**Ship Simulation Transit Scenario Modeling & Ship Pilot Study of the
Maritime Implications for Commercial Ship Transits of the Proposed
Houston Ship Channel Gate Complex**

Prepared for:
Greater Houston Port Bureau

Report Version 7.2, 11/30/2022

Figure 1. HSCGC Concept Siting from the Final Feasibility Report (page 84).

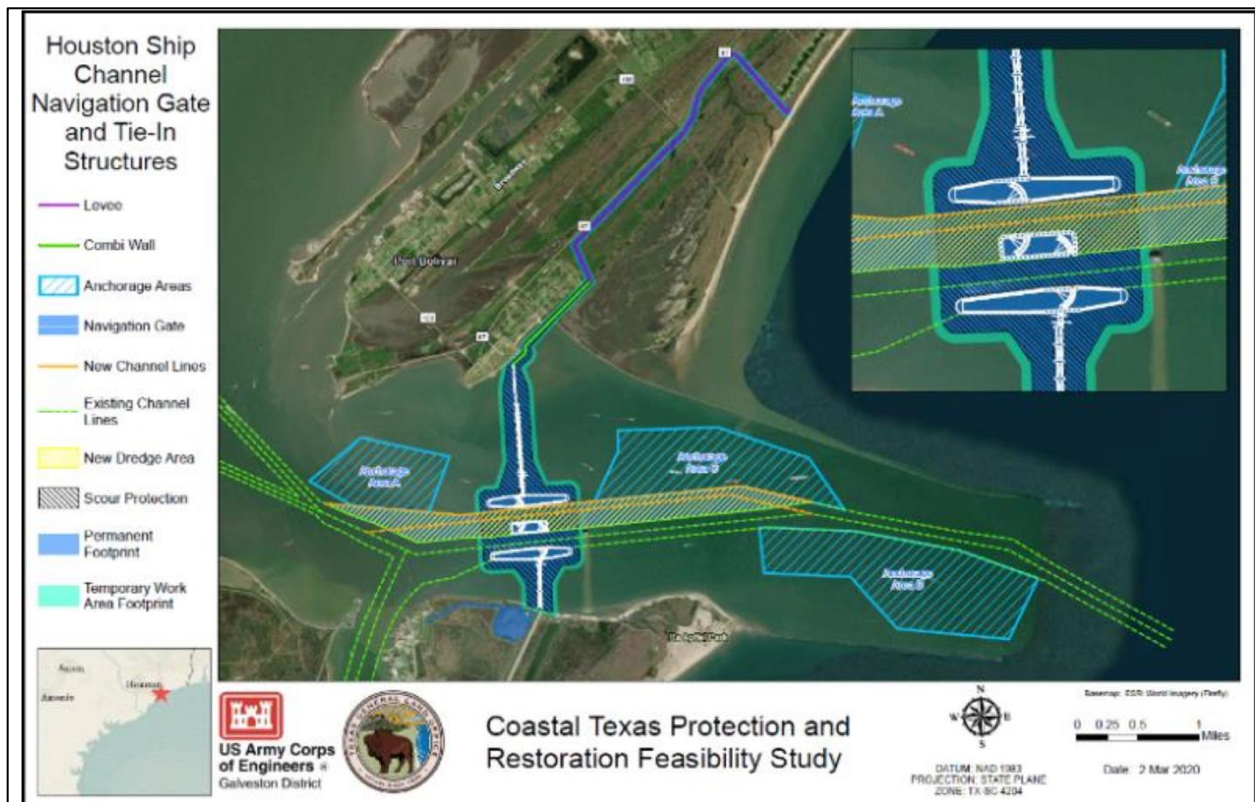
1. The HSCGC siting is too far to the west in the Bolivar Roads area of the Houston Ship Channel. The entrance to the HSCGC is only ~0.6 nautical miles from the Houston Ship Channel turn at buoys 18 and 16. This is too close, requiring a turn at a severe angle to make the turn and still align with the center line through either gate complex. While a hazard for both gate complexes, the hazard is worse for the north gate complex. This resulted in multiple ship collisions near buoys 18 and 16 as well as ship allisions with the gate complex.

2. The HSCGC is too close to the Galveston Ship Channel. The siting foreshortens the length of the turn, requiring a severe angle turn coming in and out of the Galveston Ship Channel and still align with the center line through either gate complex. Limiting the distance to navigate this turn led to ship allisions with the gates, and disruptions in the normal flow of commercial ship traffic in and out of the Galveston Ship Channel.

5. The HSCGC siting lacks a “bail-out” zone for approaching ships to abort passage into the gate complex. The gate complex can be seriously damaged by ships in extremis that lack an intentional grounding area.

1. Explore different siting locations for the HSCGC. Consider moving the HSCGC further east in the Bolivar Roads. There should be a substantial straightaway approach from either direction to the entrance of the gate complex.

Figure 2. Overhead Conceptual Rendition of the HSCGC from the Final Feasibility Report (page 85).

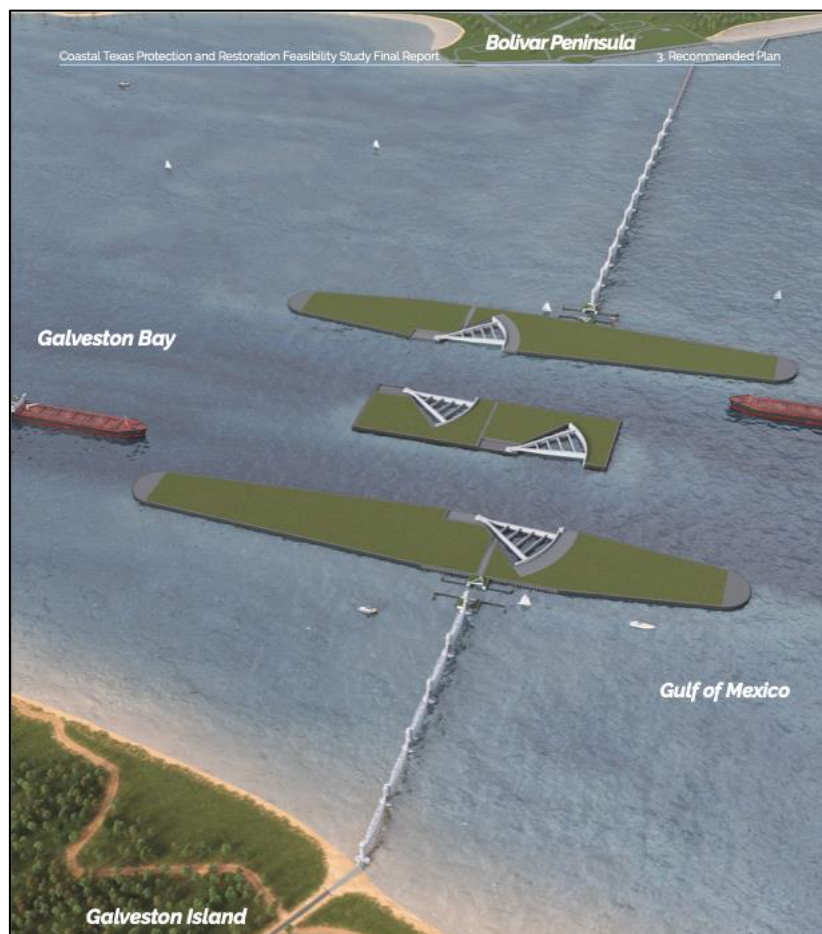
6. The 650' width of the HSCGC is too narrow. Piloted ships that entered the HSCGC on an angle or unaligned with the center of the gate entrance, experienced substantial lateral suction forces and rotational moments on the ship due to the mass and pressure of the water trapped between the ship and the gate wall. These forces affect the capability of the pilot to safely control the heading and speed of the ship when passing through the HSCGC.
7. The HSCGC's 650' wide gate openings require “perfect” piloting, leaving no room for error. On approach, ships must slow down, creating a chokepoint for ship traffic in the area. Thus, impacting the spacing, timing, and navigation of ships for miles on either side of the HSCGC for ships inbound and outbound of the Houston and Galveston Ship Channels.

8. The asymmetrical three island design is a hazard. If entering at an angle or unaligned with the center of the HSCGC, the ship's experience asymmetrical shearing forces. Shearing forces from the pressure and mass of the ship's speed and displacement forces interacting with the gate's vertical sheet-pile walls were observed at the entrance and exit of the HSCGC. On multiple occasions, the pilot lost control of the ship due to these forces.

9. The rectangle center island of the HSCGC has "square" 90-degree edges that are a potential hazard and could create extensive damage to a ship if contacted.

7. Consider redesigning the HSCGC's walls to create a sloped protection channel inside the gates, allowing a ship to ground in the channel before striking the gate walls. Alternatively, consider changing from a "no-touch" wall, to one where a transiting commercial ship can touch the side walls without doing extensive damage to the HSCGC or to the ship.
8. Consider designing three symmetrical islands for the HSCGC. Having three symmetrical shapes should reduce asymmetrical shearing forces on transiting commercial ships.
9. The HSCGC should have excellent navigation aids including inbound and outbound center line ranges.

Figure 5. Shearing Forces on misaligned Aframax class tank vessel passing through the tested gate system

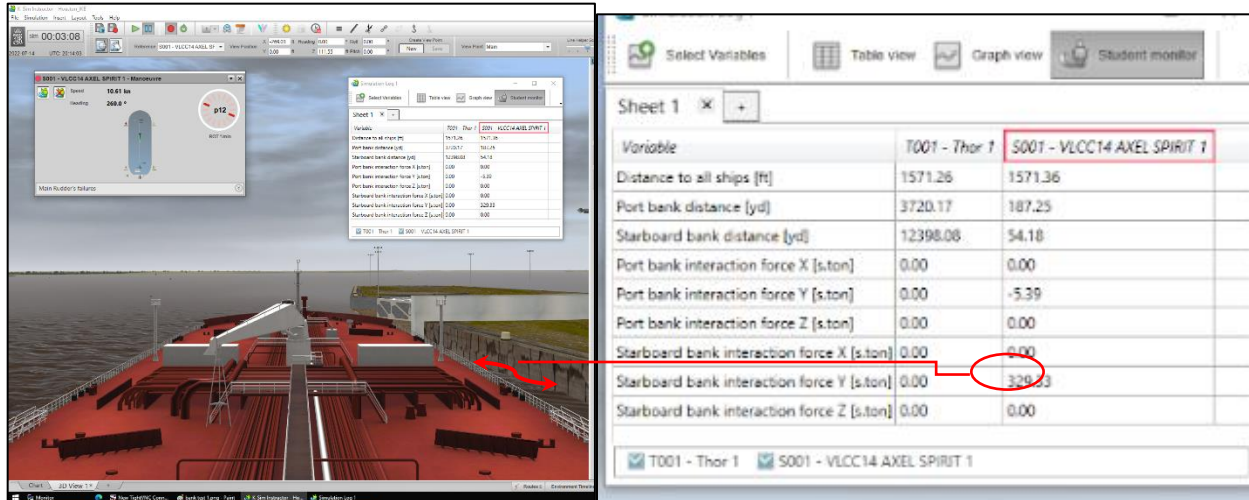
It is expected that vessels will become unaligned with the HSCGC's centerline while transiting through the gate, given random events, shipboard emergencies, and/or human error. Analysis of the shearing forces below on an unaligned tank vessel, passing through the tested gate system, shows that an Aframax-class tank vessel at a distance of 162' from the sidewall of the gate, at a speed through the water of 10.6 knots, generates 392 tons of shearing force on the vessel. This shearing force caused an out-of-control situation for this vessel.

Figure 6. Outbound Vessel out of control due to shearing forces in the tested gate system

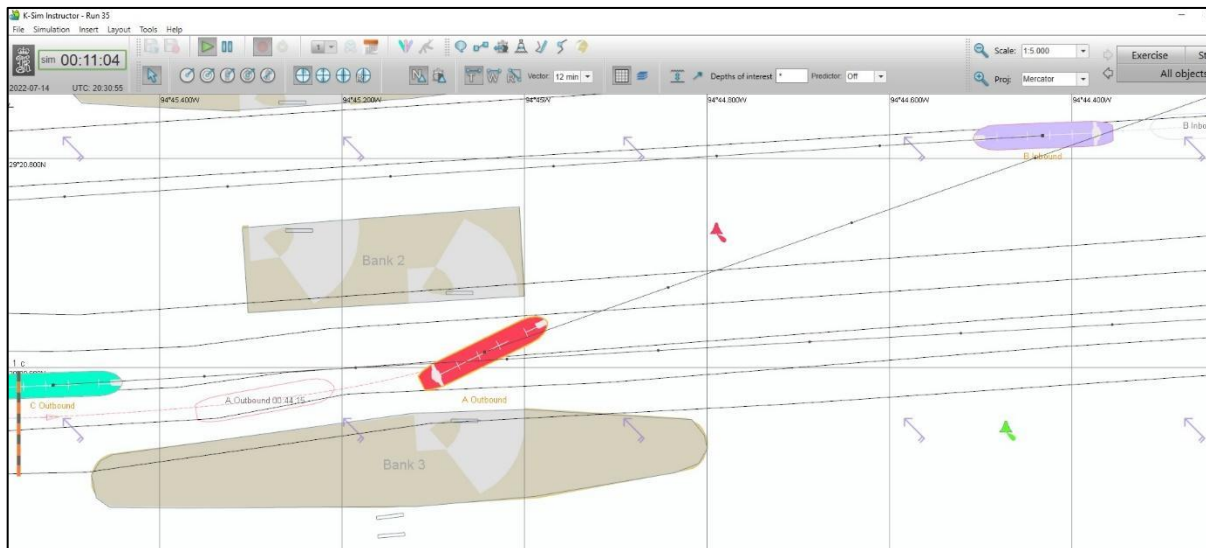
In the below example, the Aframax-class tank vessel (Red, A) was outbound through the HSC, transiting through the gate system, they are mis-aligned due to previous maneuvers with the other Aframax-class tank vessel outbound from the Galveston Channel (Turquoise C), which is closely following. This navigation setup causes the lead vessel (Red, A) to be misaligned and too close to the south wall of the gate system. The asymmetrical shearing forces due to close proximity to the oblong island wall upon entry of the HSCGC overwhelmed the piloting control of the vessel, and the vessel ran out of control, across the channel lanes and towards the north ship channel of the other gate.

In summary, there are asymmetrical shearing forces acting on transiting commercial ships when entering and exiting the gate complex. These occur both when the transiting ship is on the center line and the shearing forces increase substantially if the transiting ship is misaligned due to the asymmetrical shapes of the islands. The outer islands are oblong, and the center island is a rectangle with substantially different lengths. The size and particularly the length of the islands in the gate complex need to be symmetrical to prevent shearing forces on transiting commercial ships.

Figure 9. Run #25, Outbound ship has flood current, could not get aligned with gates after turn, entered gate system at an angle

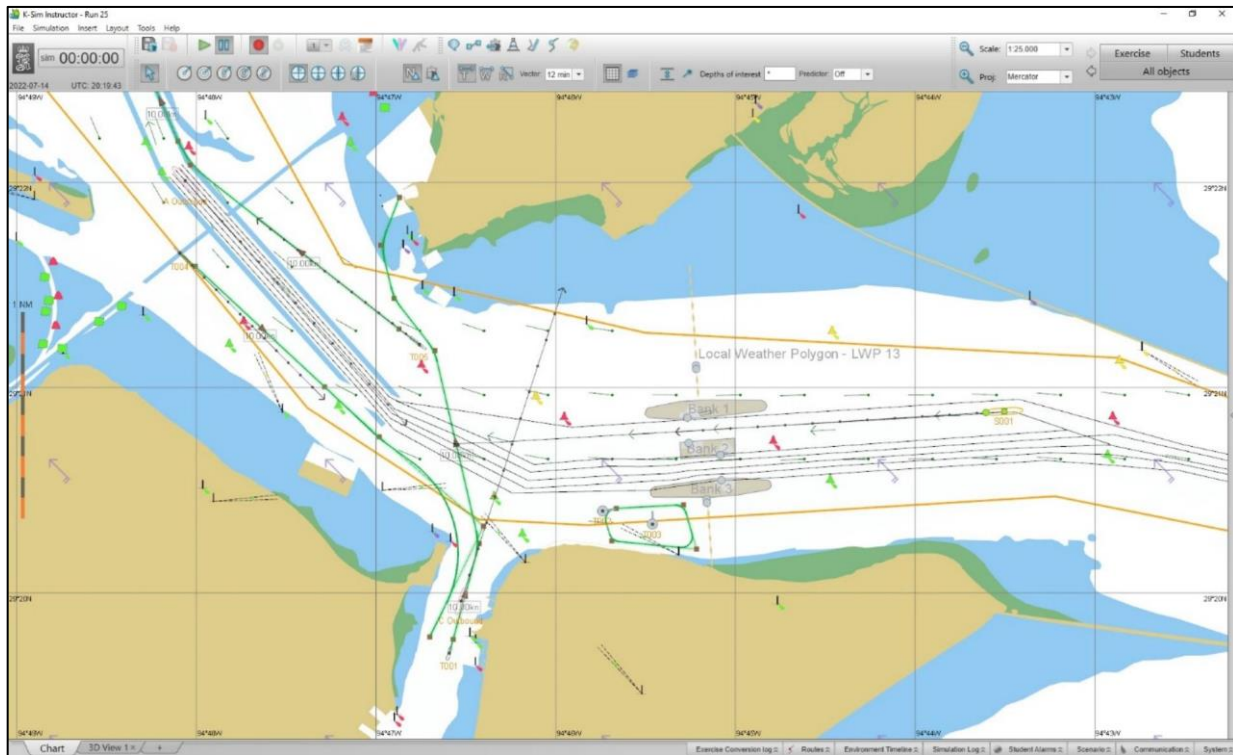
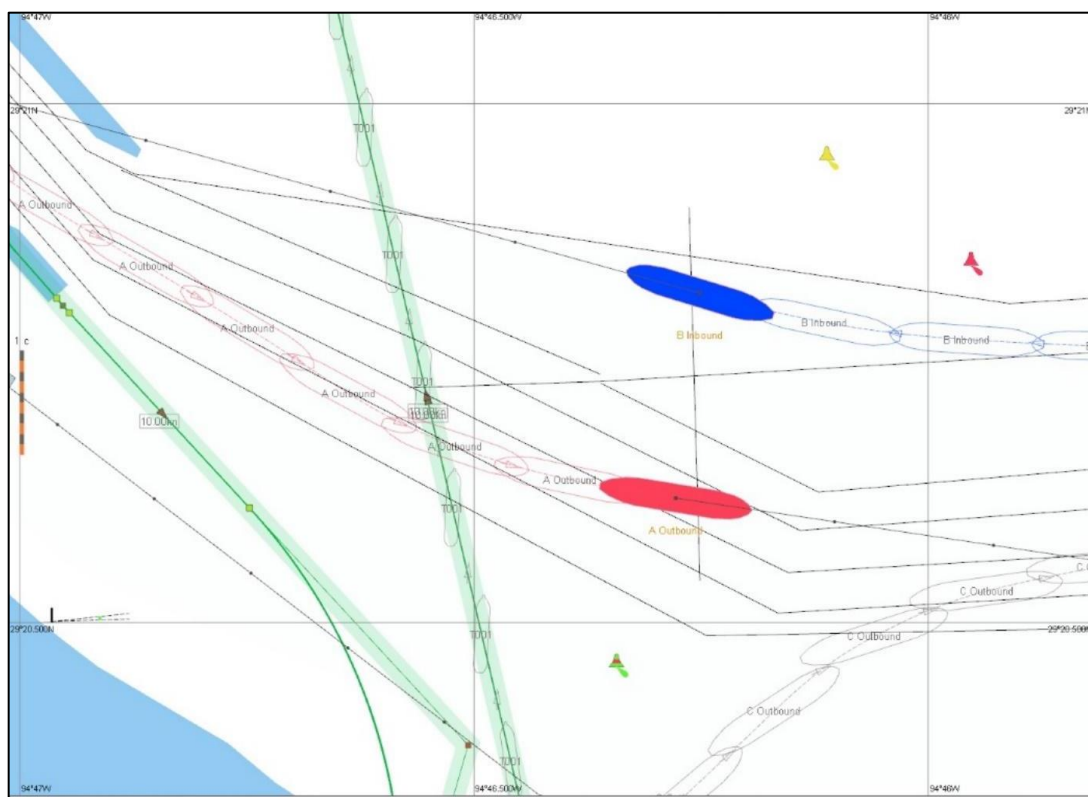
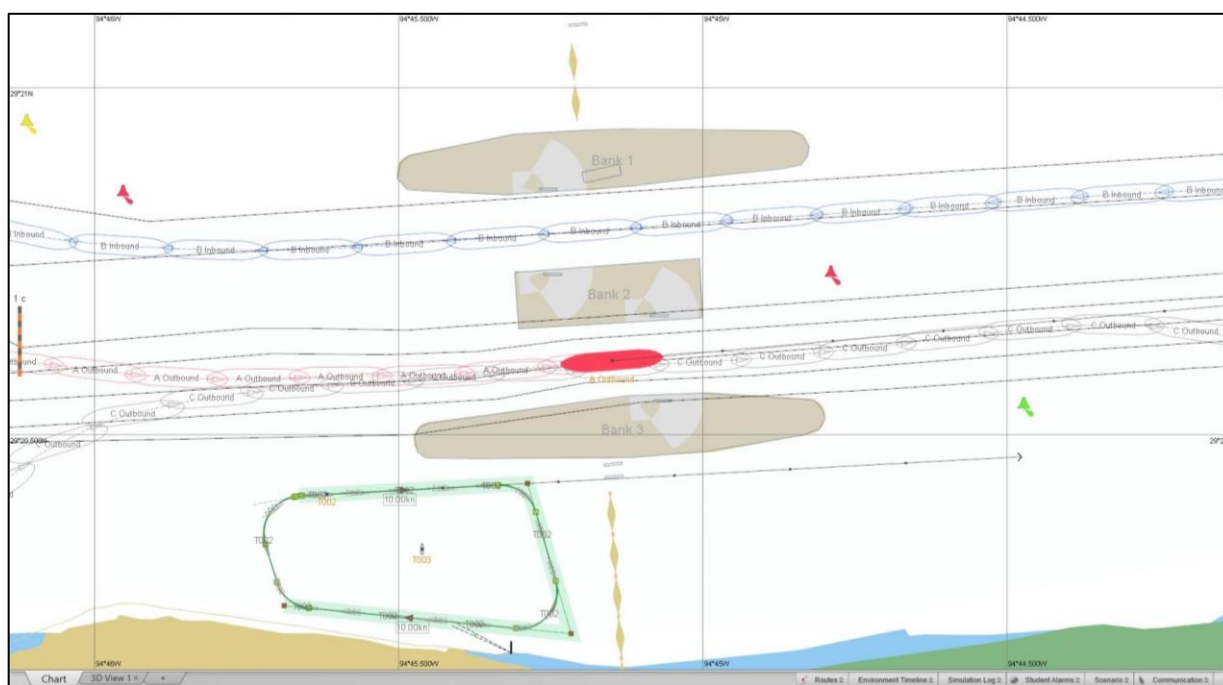
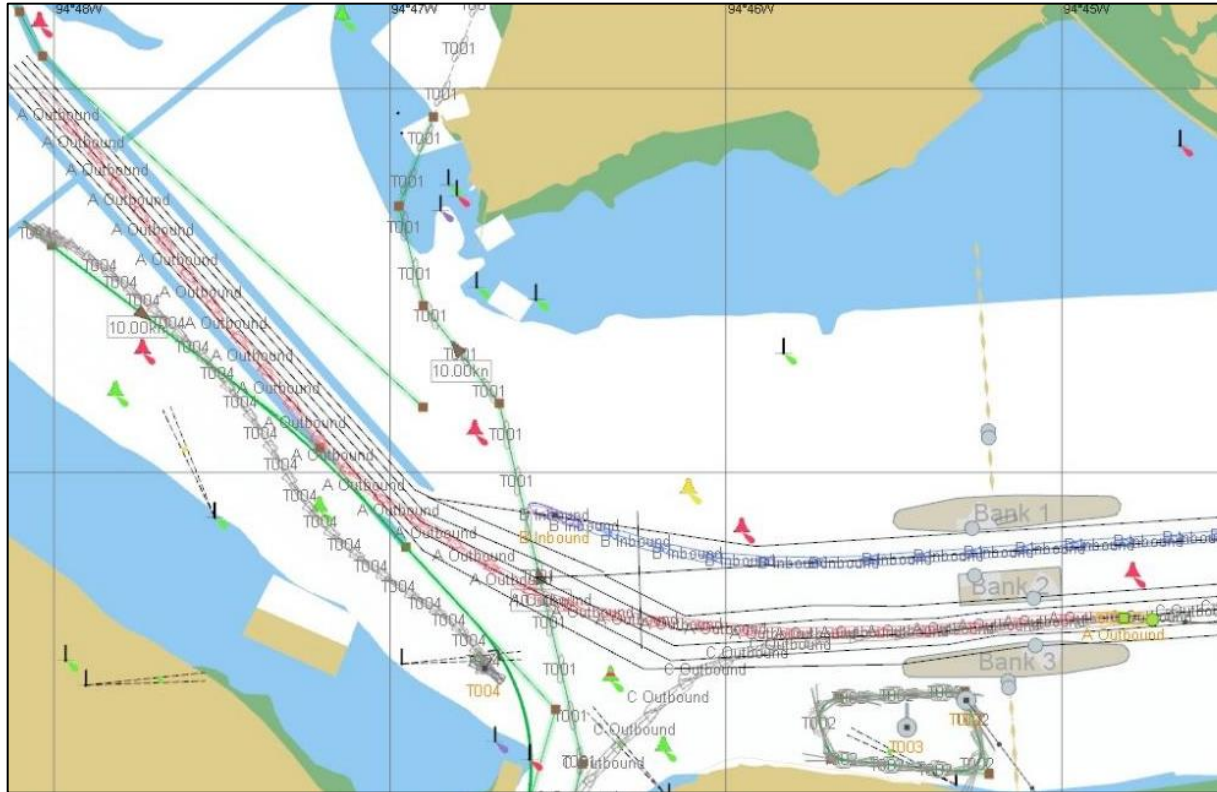
An example of this issue occurred on run #25¹², displayed below in the series of figures. These show an outbound ship with a flood current (2.5 knots), in clear daylight conditions, with wind 135 degrees at 20 knots, starting at buoys 25/26 experienced a hazard of not being able to align

with the entrance of the south gate. This in part was caused by the ship needing to get deep into the turn at buoys 18 and 16 when meeting an inbound ship. The outbound ship was using orders of full ahead and full rudder over, equivalent to emergency ship handling, to make the turn and try to get aligned with the gates, which they were unable to resulting them entering the gates at an angle. Thus, even with both gates open, such a maneuver requires “perfect” ship handling, leaving no room for error.

Figure 15. Run #31, outbound ship transiting through the south gate at a slight angle

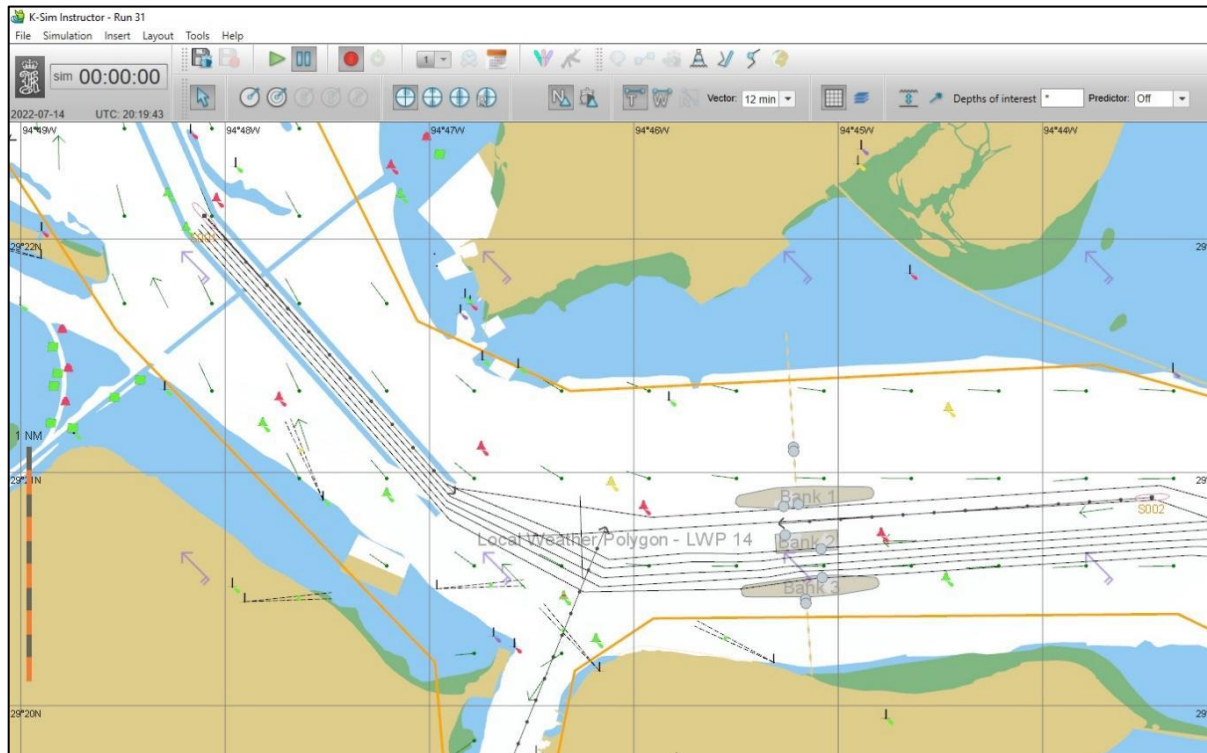
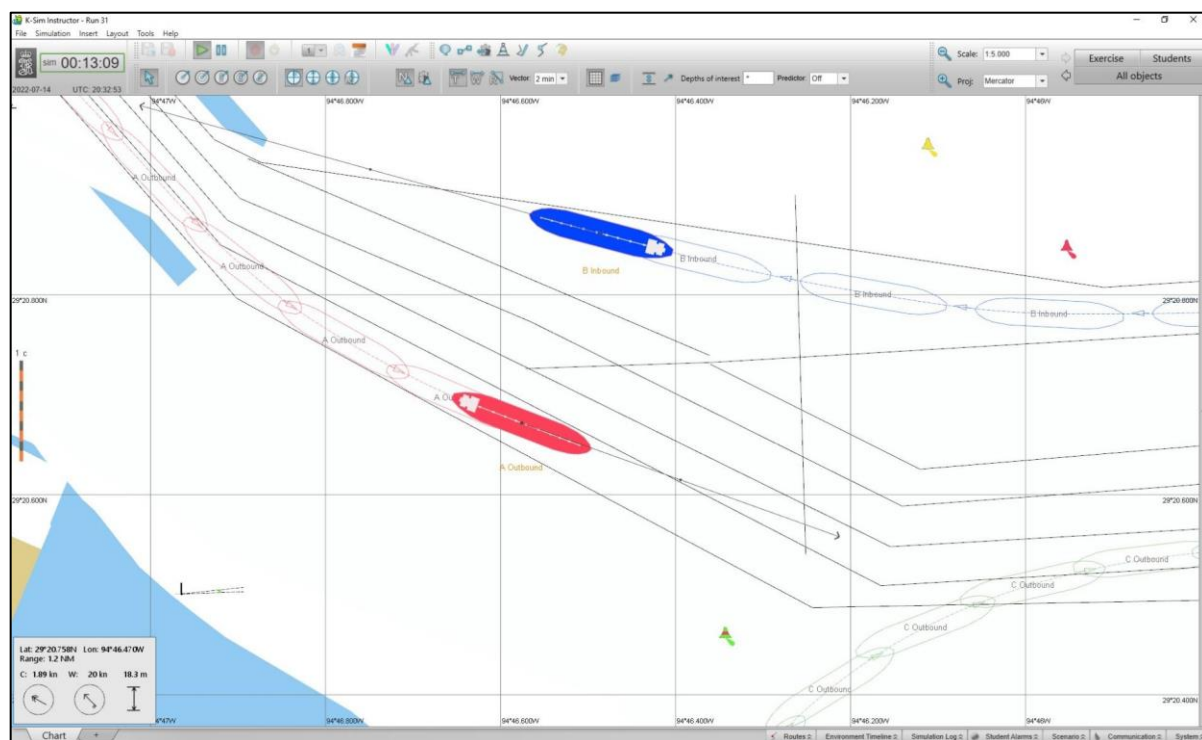
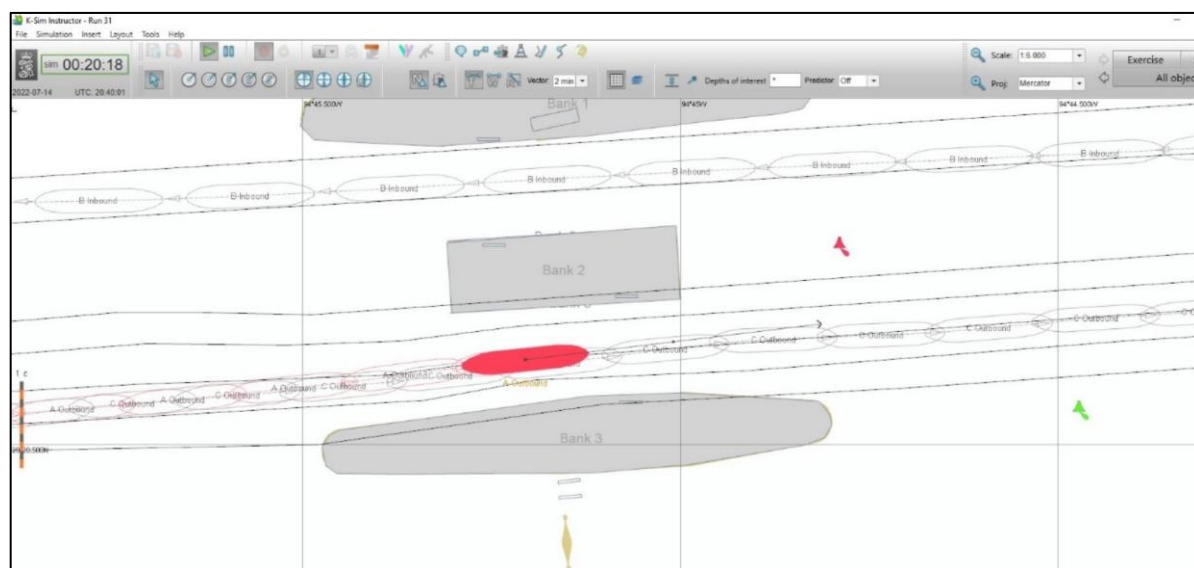
A third example of the hazard of an outbound ship getting aligned with the south gate entrance on a flood current (2.5 knots) is from run #31. This scenario used the common test model of VLCC13 that is frequently seen by the Houston Pilots. The Galveston-Texas City pilots were in attendance during this session and took part as they piloted an outbound ship from the Galveston Channel that went through the south gate prior to the outbound ship from Houston.

commented that this will require “perfect” piloting. Also, they stated that the distance between the turn at buoy 18 and 16 and the gates is not enough to get aligned with the gates. This issue becomes more pronounced when the current is increased, and wind is added.
